SITE: Land to the east of Titley Wastewater Treatment Works, Titley, Herefordshire
TYPE: Planning Permission
DESCRIPTION: Proposed creation of an Integrated Constructed Wetland.
APPLICATION NO: 222619
GRID REFERENCE: OS 348961 - 263522
APPLICANT: Mr David Jones
AGENT: Mr Ed Thomas

Figure 2: EA Surface Water Flood Map, October 2022

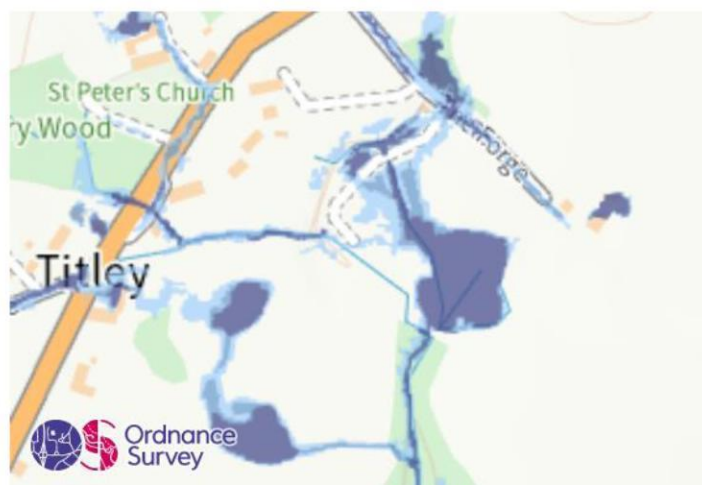
Review of the EA's Risk of Flooding from Surface Water map indicates that the site is at risk of surface water flooding.

We understand that any excavated material as part of the development will not be used to build up the land and existing overland flow routes will not be impeded or diverted. However, given the nature of the proposed development, the risk of surface water flooding is not a significant cause for concern.
